Flight Procedures Cover Page	Task Action: Abbreviated Amendment	Task Type: IAP	Estimated Chart Date: 01/22/2026	APWS Task ID: 6D98DDFDC11F4958A98E51207C425144	APWS Project ID: 8546E936AF02416789032F228FE8D614
Procedure: RNAV (GPS) W RWY 29 AMDT 0B		Enroute: NO	Specialist: Clark, Jacob		Agreement Number:
Airport ID: KEWR			Airport City: NEWARK		State: NJ
Facility ID:	Facility Type:	Flight Inspection Remark Type:

RNAV (GPS) W RWY 29

NEWARK LIBERTY INTL (EWR)

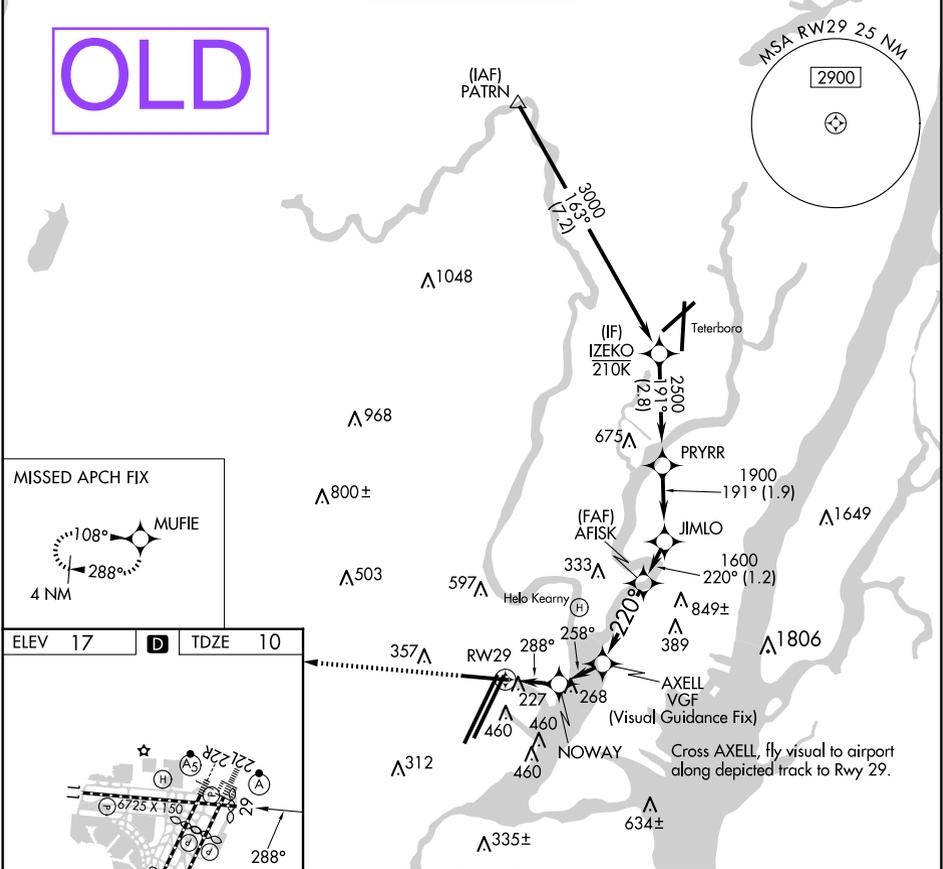
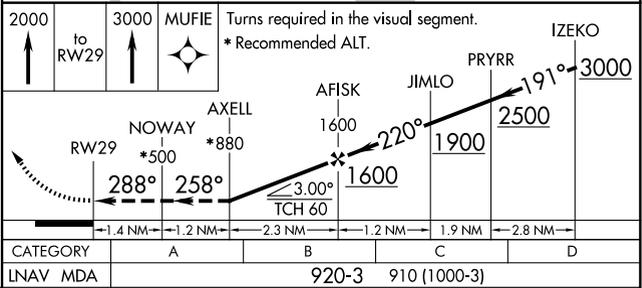
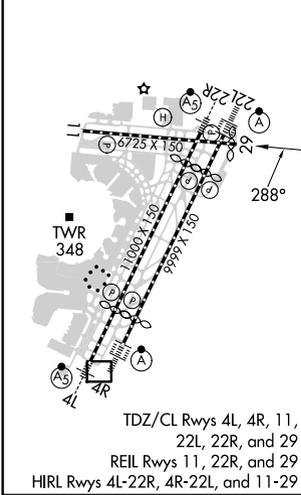
ADDED NON STANDARD TRAFFIC NOTE: "CHART NOTE: CAUTION, DEPARTING TEB RWY 24 TRAFFIC CLIMBING TO 1500'
 MSL."

CAUTION, DEPARTING TEB RWY 24 TRAFFIC CLIMBING TO 1500' MSL.
